WELL NAME: ANDREW 23-15, API #: 071-08460, INSP. # 716300582

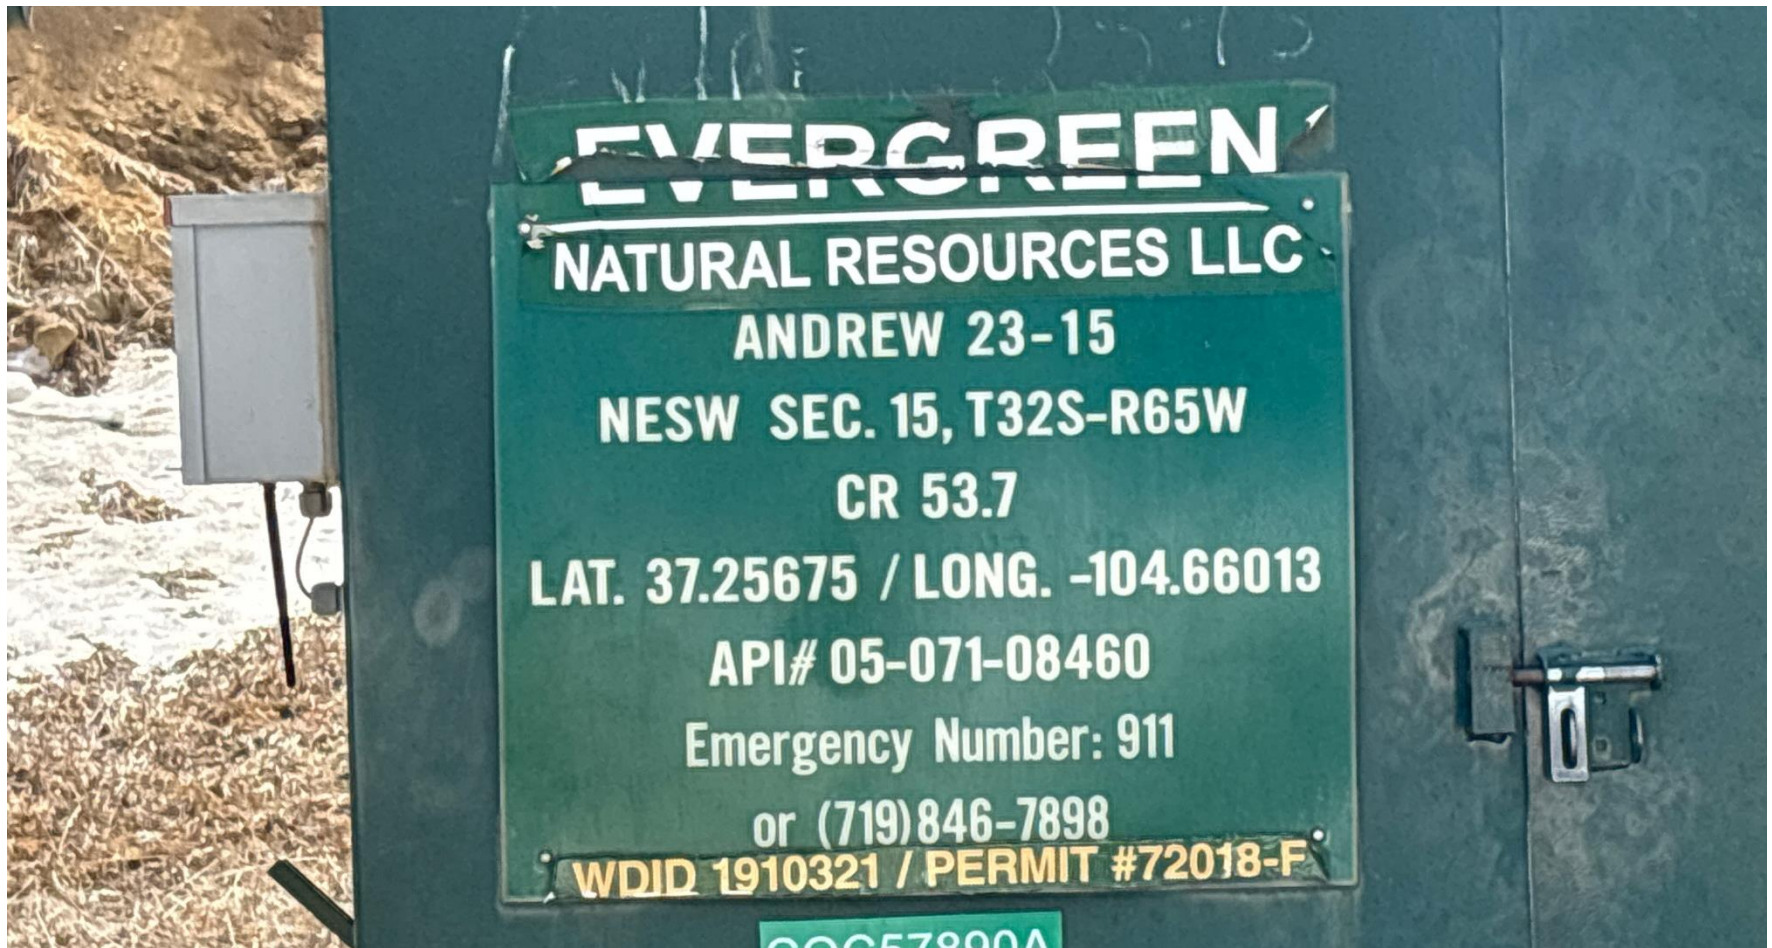
**PHOTO 4: OILY WASTE IN PRIME MOVER ENGINE SKID. DRAIN OILY WASTE REPAIR ALL LEAKS AND REMOVE OR TREAT IMPACTED SOIL PER RULE 1002..(2).D & 1002.f.(2)B, Comply with general provisions of the oil and gas act for wildlife protection AND SB-181. CA DATE 2-26-2025**

**PHOTO 5: OILY WASTE IN COMPRESSOR SKID. DRAIN OILY WASTE REPAIR ALL LEAKS AND REMOVE OR TREAT IMPACTED SOIL PER RULE 1002..(2).D & 1002.f.(2)B, Comply with general provisions of the oil and gas act for wildlife protection AND SB-181. CA DATE 2-26-2025**

**PHOTO 6: AREA OF IMPACTED SOIL AROUND PRIME MOVER ENGINE SKID. Conduct maintenance on equipment, cleanup stained material and review self inspection processes. COMPLY WITH RULE 1002,.(2).D. CA DATE 3-2-2025.**
